## Alachua County Board of County Commissioners

November 13, 2025

RE: Tara April Special Exception

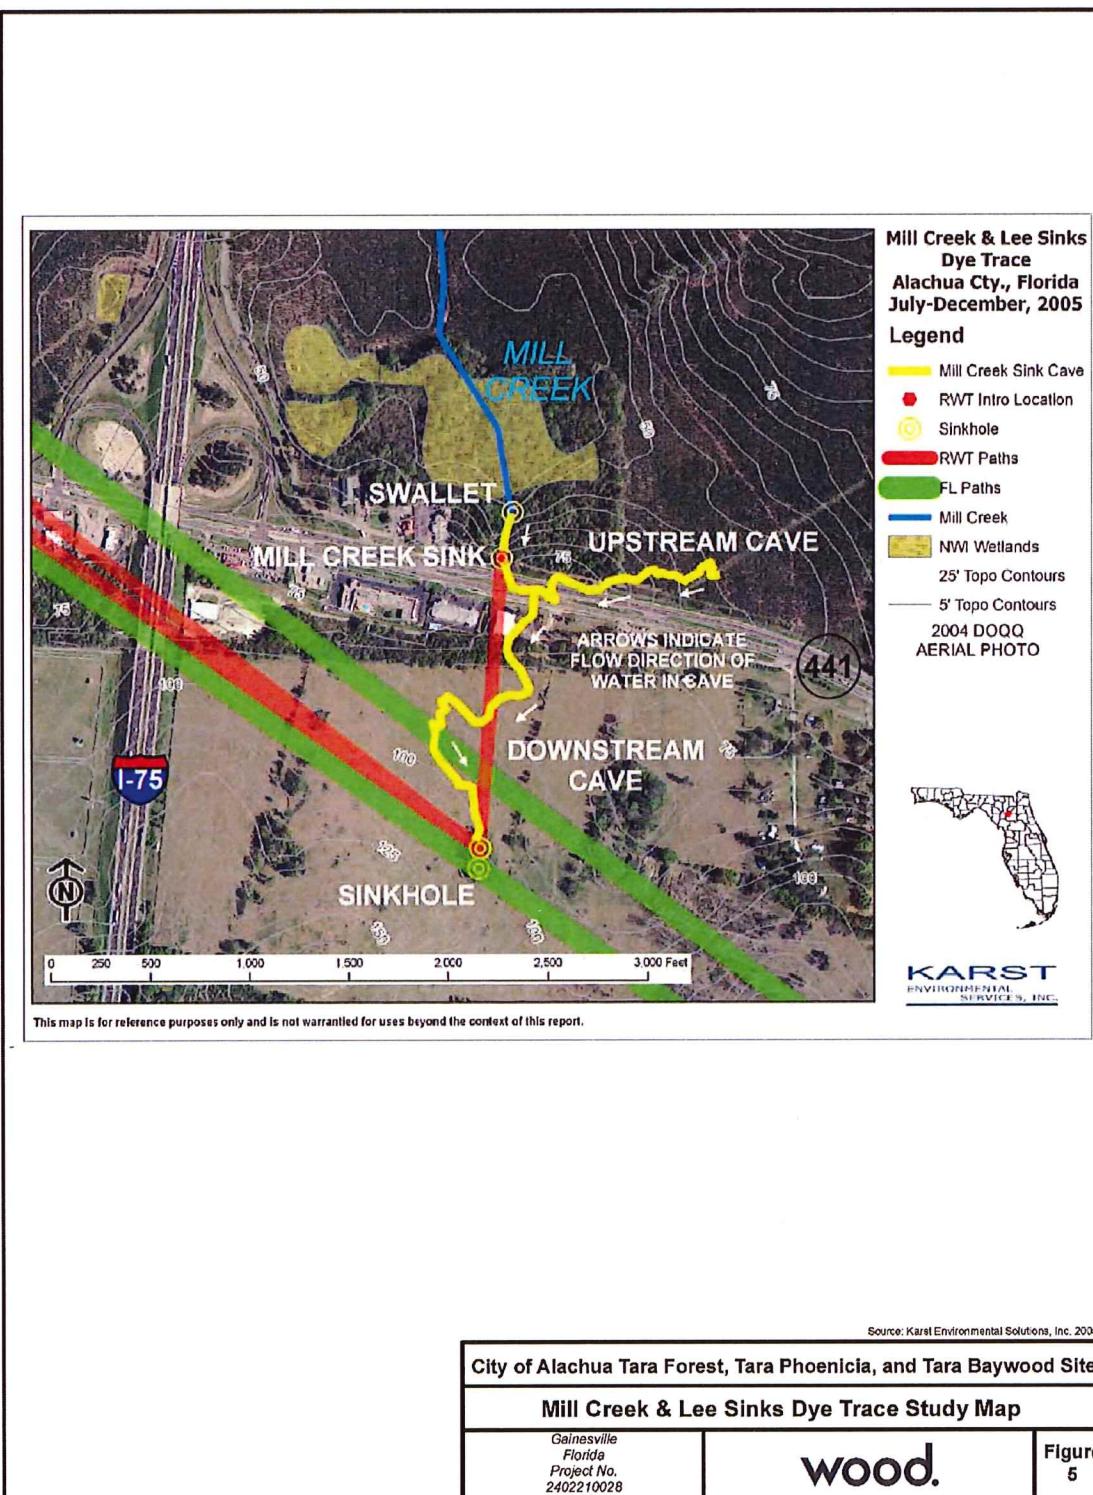
Based on a comparison of the site topographic information since 1962 (USGS), the entire western boundary of the property (<75ft elevation) appears to be an area potentially experiencing active ground subsidence. Based on the 1962 topographic map there are sinkholes present at multiple locations along this western boundary. The historical topographic maps (USGS), also indicate the presence of a sinkhole in the northwestern portion of the site and in the general vicinity of the northern portion of the eastern boundary (**Figure 6**).

In general, within the lower Mill Creek Valley (elevation < 75 ft contour, western portion of the property), may be susceptible to subsidence, and development in these areas should consider the possibility of subsidence or sinkhole formation. Further, the depressional areas and stream valleys identified in **Figure 6**, and the Mill Creek Sink Cave shown in **Figure 5**, may experience more settlement over time, with potential for sink hole formation.

Wood recommends evaluating the likelihood of ground loss due to karst by performing site-specific engineering and geological studies. Following additional investigation, Wood recommends avoiding development in areas that have shown ground loss between the 1960's and today and selecting areas for development at higher elevations.

# **Attachment C**

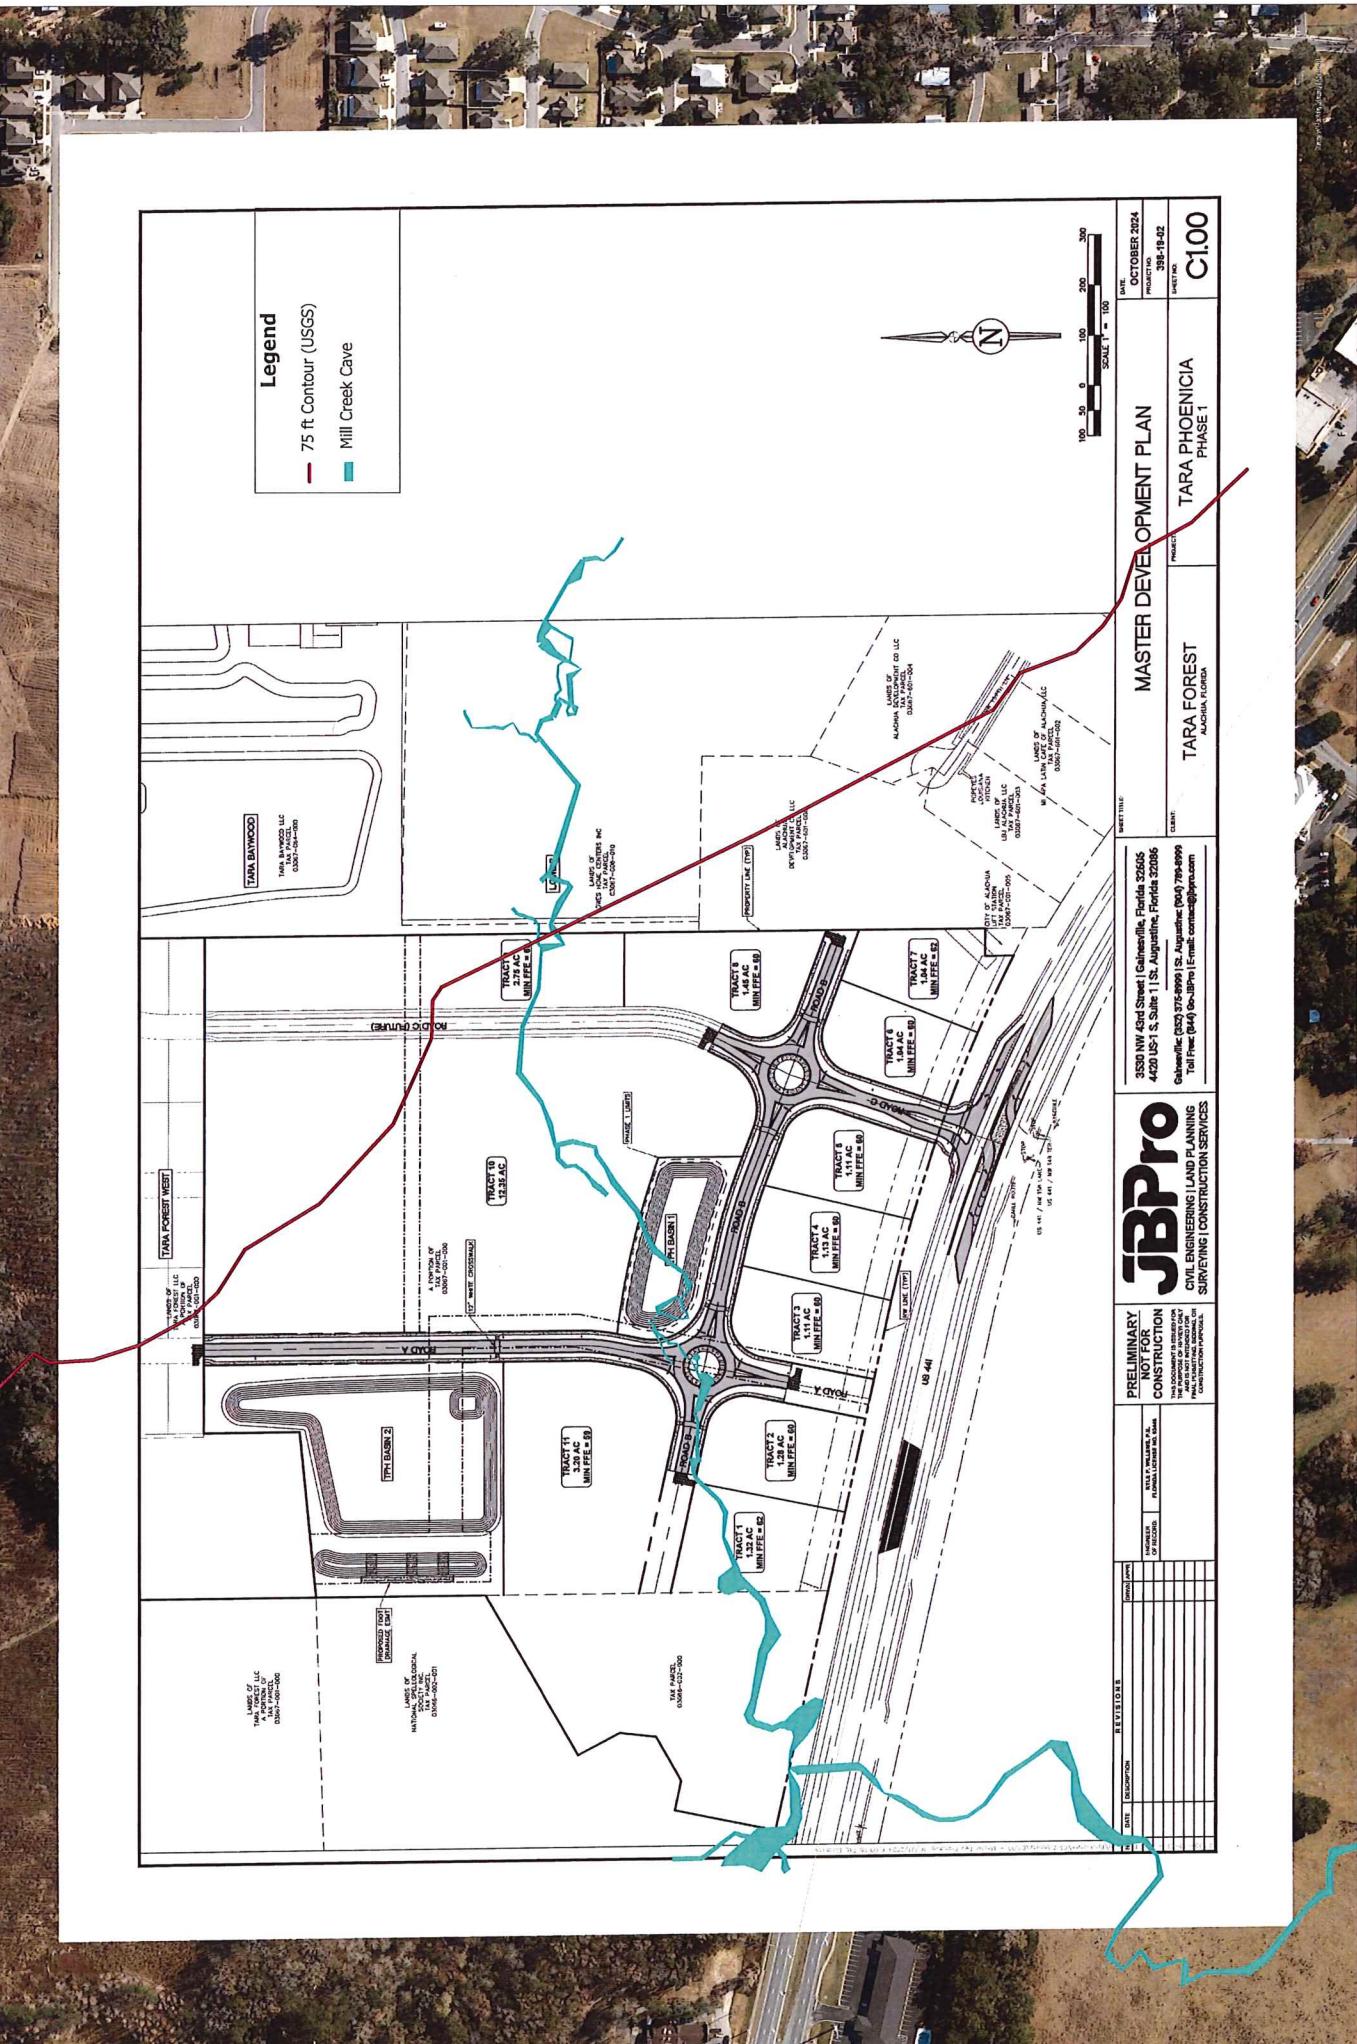
The National Speleological Society has performed extensive mapping of the Mill Creek Cave System and has shared the mapped extents with Alachua County. A figure is attached to this letter showing the extent of the proposed Tara Phoenicia development with relation to that 75-foot contour and the mapped cave system (Attachment C). This mapped cave system captures areas large enough for a diver to fit. It is very likely that this cave system is much more extensive and complex and extended by smaller conduits that do not allow human passage, but do allow the movement of water and any contaminants.

Alachua County strongly encourages the City of Alachua to require the applicant to perform further geophysical investigation via Electrical Resistivity Imaging (ERI) surveys prior to commencement of construction activities and prior to approval of site design expansion, as recommended by Wood’s site assessment report and geotechnical engineer. Because of the mapped Mill Creek Cave system, a significant geological feature as defined by the City’s Comprehensive Plan, and the known nature of active karst formation in the area, it is irresponsible to perform any significant land development and earth moving activities without thorough subsurface exploration. While sinkhole formation is a common consideration for land development within Alachua County, these known characteristics for this area warrant this additional data gathering to best protect public health and safety and requesting this analysis and investigation is consistent with Objective 1.7 *Geological Resources* of the Conservation and Open Space Element of the City’s Comprehensive Plan, which states the City shall identify, protect and conserve significant geological resources and their natural functions.

Figure 10. Cross-County Fracture Zone.

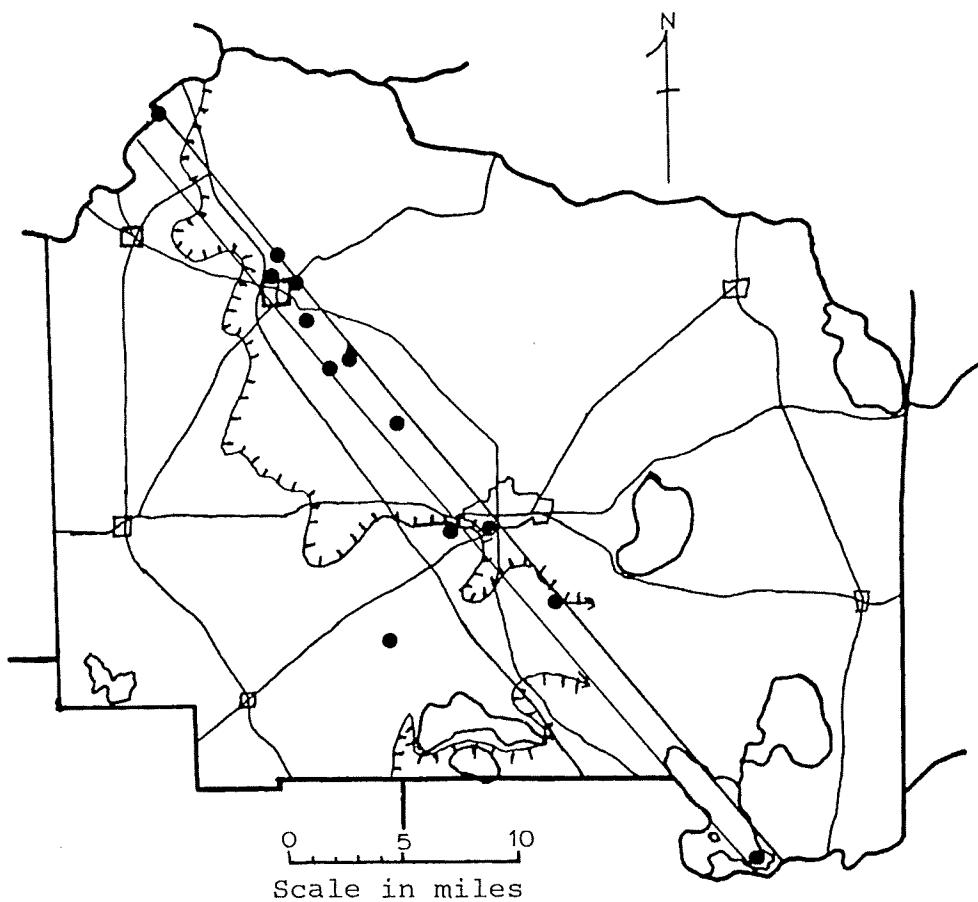
The 1977 Bureau of Geology’s “The Geology of the Western Part of Alachua County, Florida” delineates what is known as the cross-county fracture zone, which can be seen in Attachment D. This cross-county fracture zone is described as follows, “This linear trend of solution features is considered to be a direct result of an extensively fractured zone both in the Crystal River and the Hawthorne Formations. Preferential solution occurred along this fractured zone in the Crystal River Formation. This was accentuated by downward percolation of ground water along joints and fractures in the Hawthorne Formation.” This explains why there are so many subterranean voids in this area and such a short travel time to the Santa Fe River & Springs. Preferential solution/groundwater flow could result in the formation of much larger voids compared to other parts of Alachua County. The entirety of both the Tara April and Tara Phoenicia sites fall within the cross-county fracture zone.
